Commercial/Multi-Family Design Review Committee

Friday, October 31, 2025

1. [24-0583](#) Review of plans for the commercial development located at 3800 State Rd 16.
(7 Brew Coffee)

SUBJECT: COMMERCIAL DESIGN REVIEW PROJECT
7 BREW COFFEE- VALLEY VIEW MALL

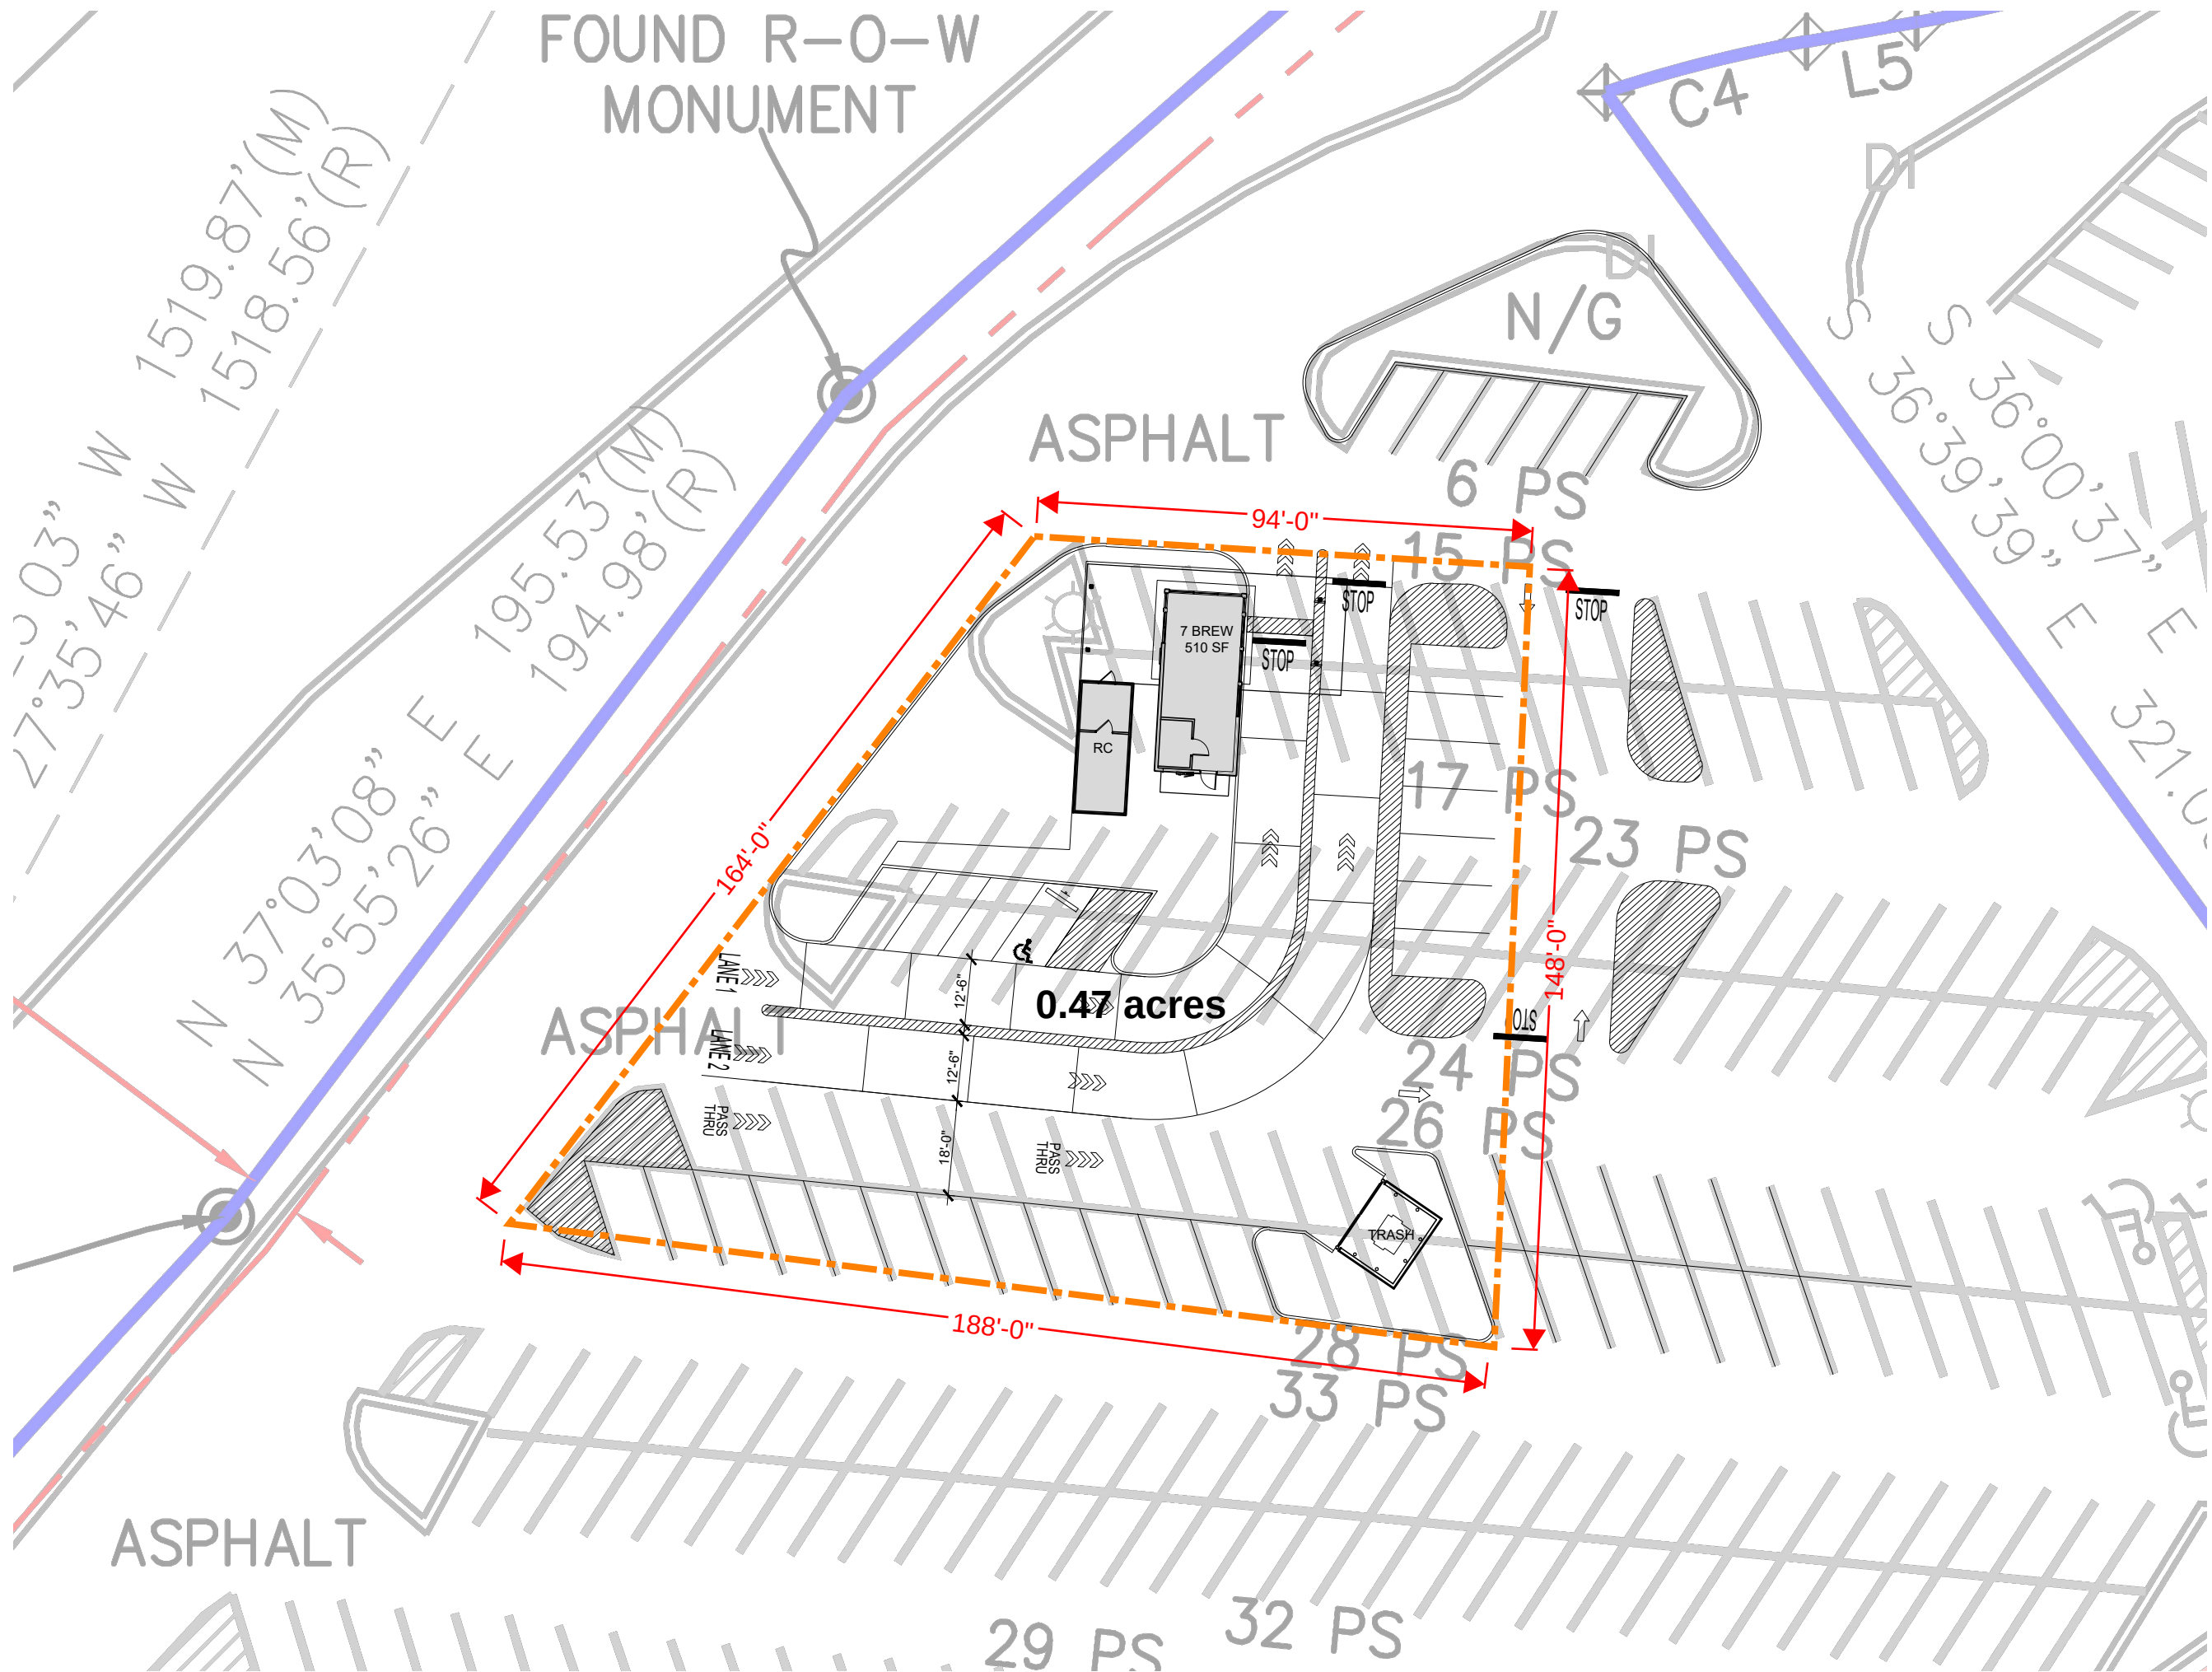
- 1) Add all dimensions of all parking spaces and one ADA designated space.
- 2) Indicate access to building from ADA space on the site plan.
- 3) Add dimensions of drive thru lanes and aisles on the site plan.
- 4) Remove existing parking overlay on the site plan.
- 5) Will need to submit a Photometric Plan. Include a summary of fixtures and model numbers used. Plan must also provide calculations/foot candles 25ft outside off of property lines. (Jamie Hassemer)

- 1) Will need to submit a Certified Survey Map to create new parcel.
- 2) No parking closer to the street than the building. Must provide a clearer site plan.

- 1) Location is a problem. Need direct access to utilities but buildings are over utilities. Need to move project to the south or have mall own utilities.
- 2) Need Utility Plan to show connections.
- 3) Subject to connection fees.

A2.0

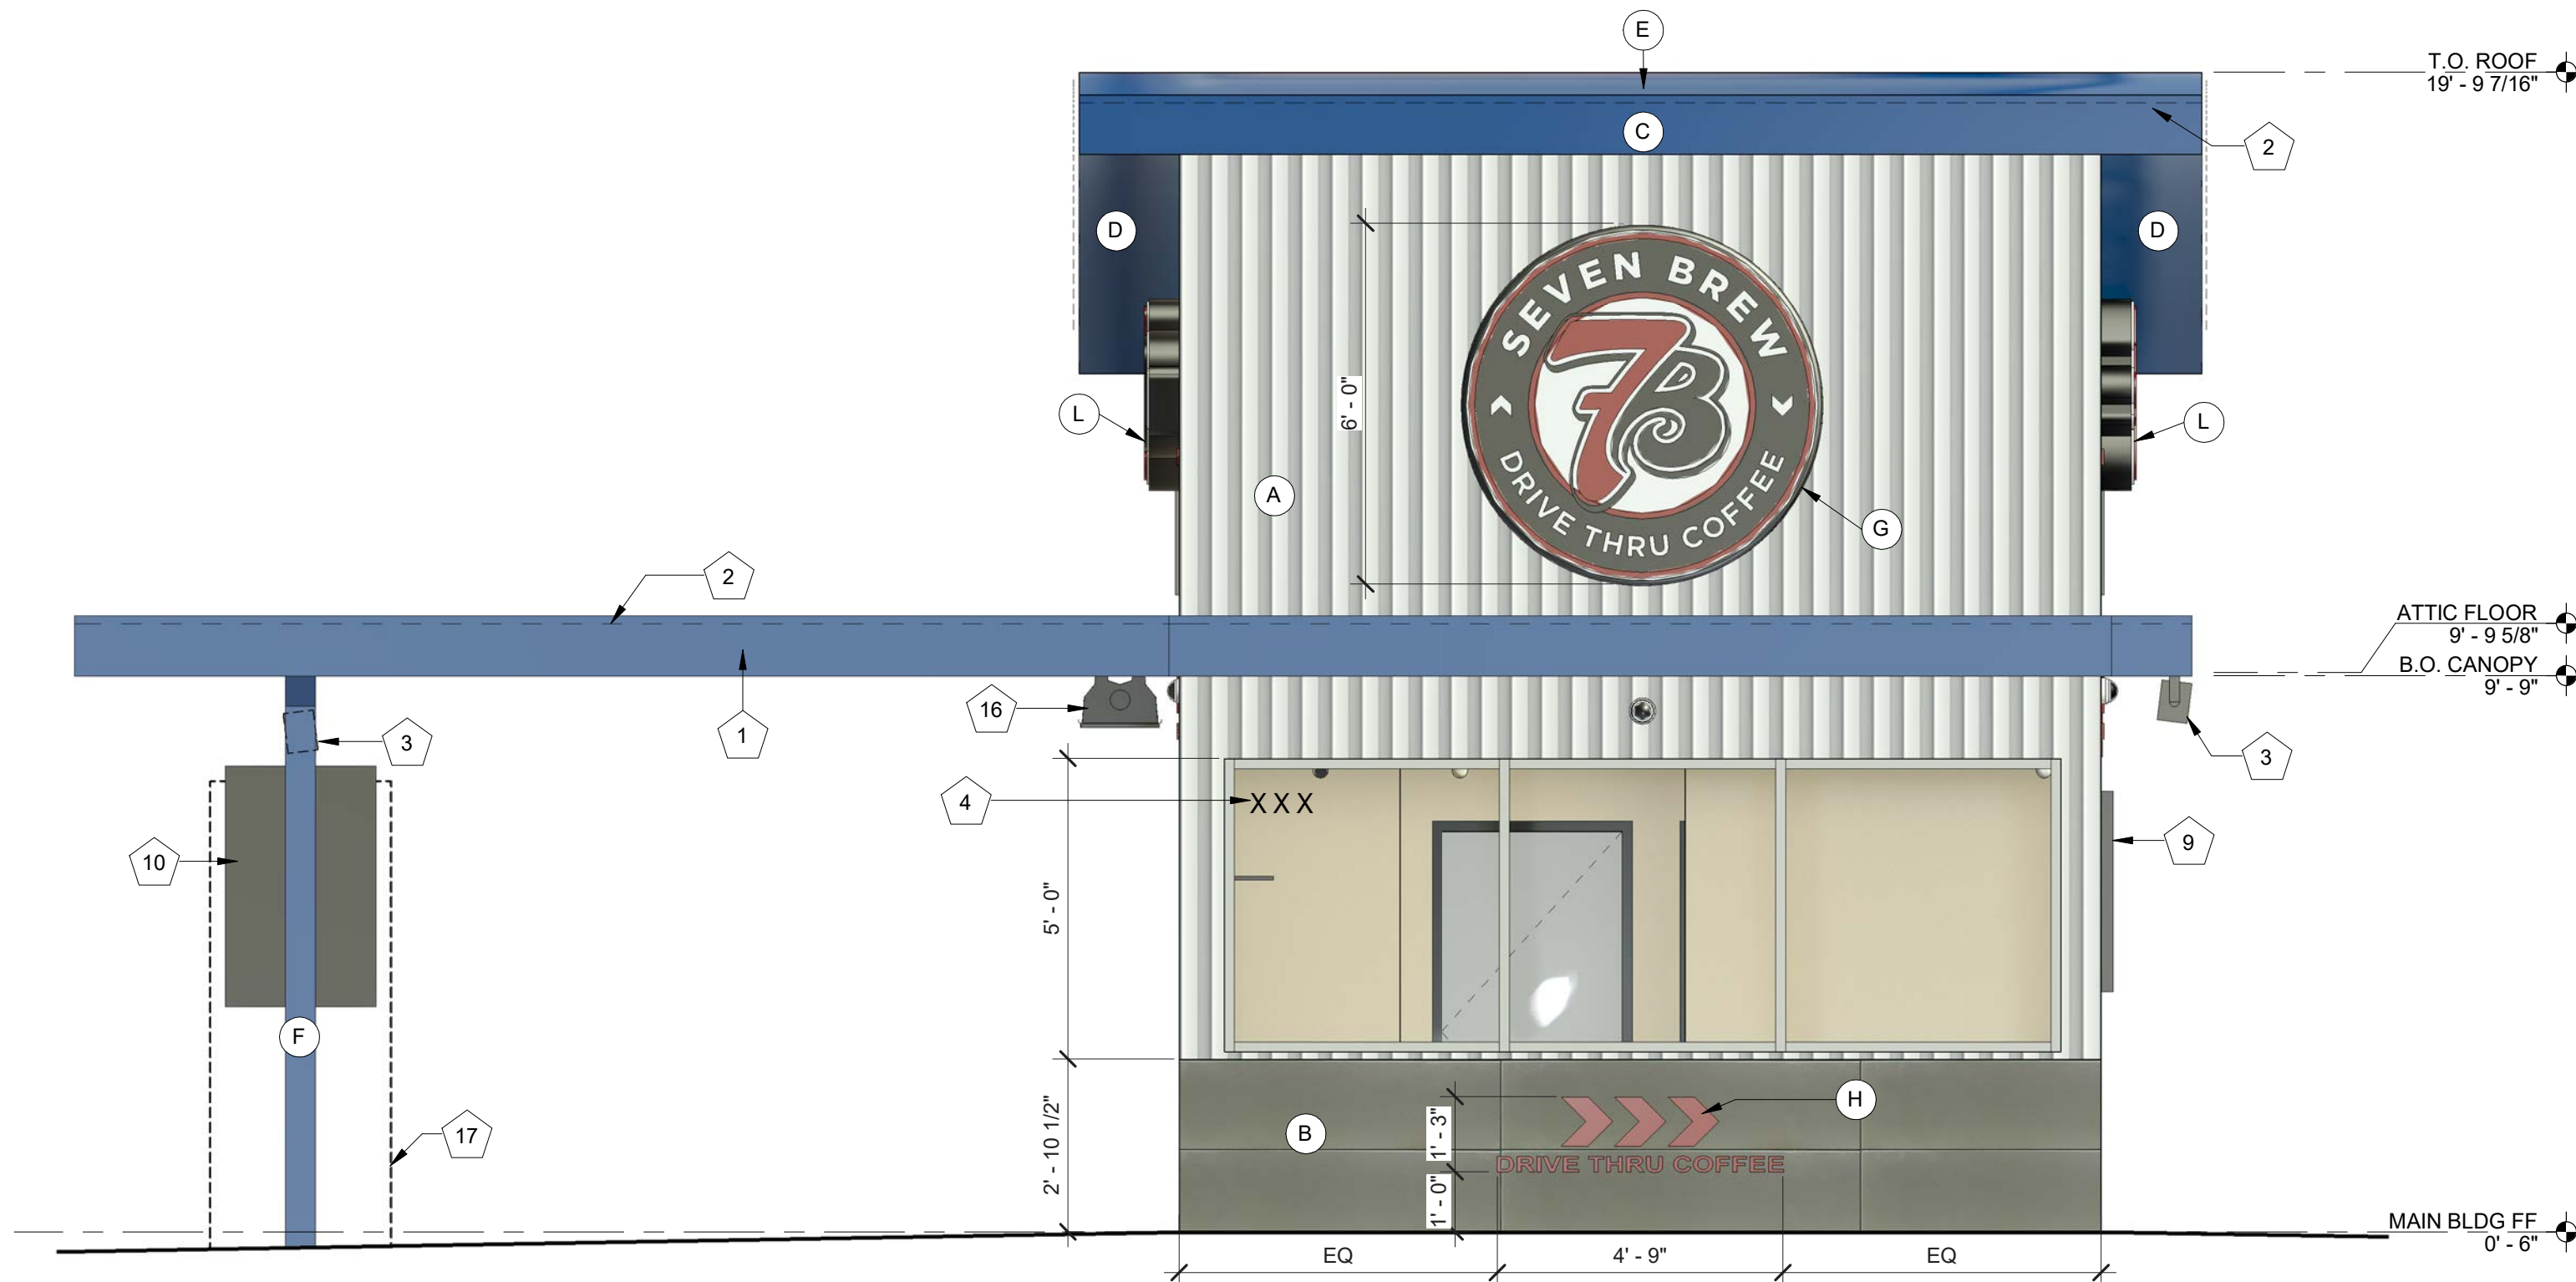
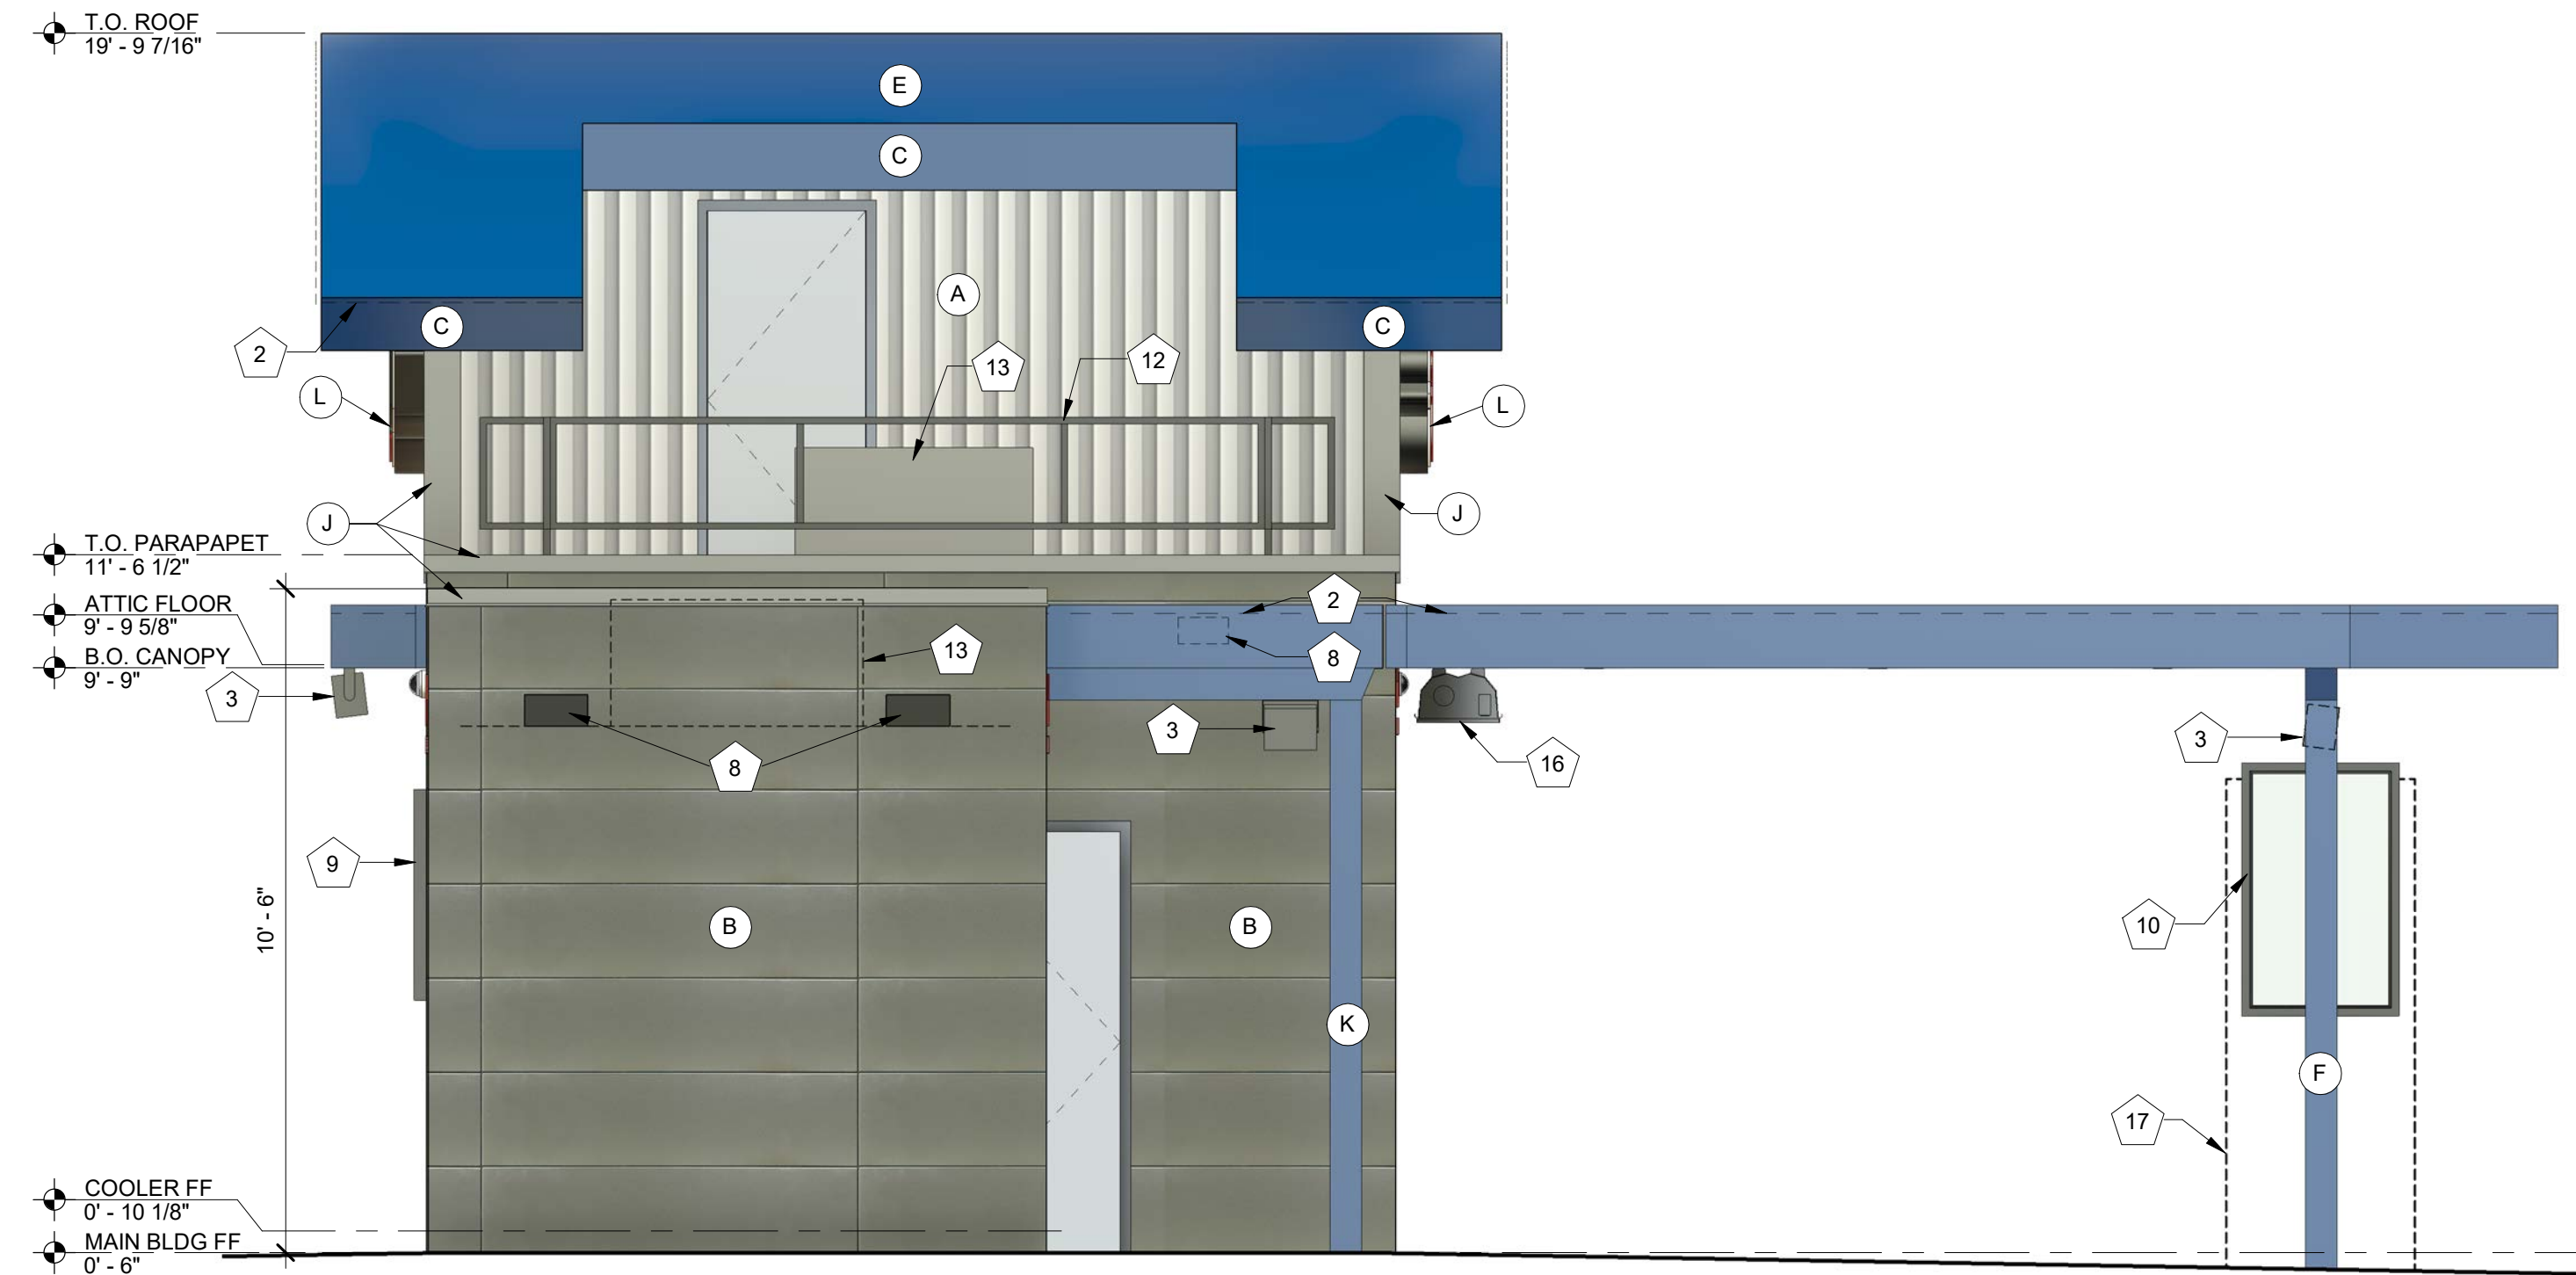
- 3)
- 4) Non-architectural metal is not a permitted exterior material. Please provide additional material to support the proposed vertical metal siding.
